KEYSTONE ELECTRONICS CORP.			
www.keyelco.com • NEW HYDE PARK, NY 11040 • Tel (516) 328-7500			
PART NAME			
SNAP RIVET			
MATERIAL			
NYLON 94V-2 (BLACK COLOR)			
FINISH		DRN BY	DATE
NONE		BOONE	9.29.06
		APP'D	SCALE
		RH	3X
TOLERANCES		INCH	[MM]
DECIMAL		± .010	[± 0.25]
ANGULAR		± 1°	
UNLESS OTHERWISE SPECIFIED		CODE	DWG NO.
		C	3446

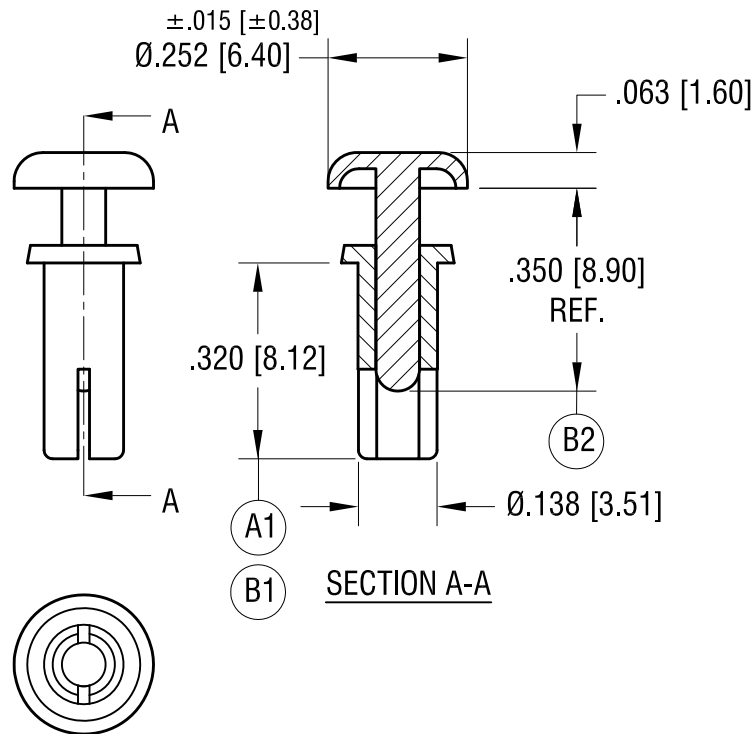
1.3.01	① WAS $.340$, ② WAS $.350 \pm .010$ CHANGE AS PER ECN 01-000	B
7.15.21	① WAS $340 \pm .010$ CHANGE AS PER ECN 21-069	A
DATE	DESCRIPTION	REV.
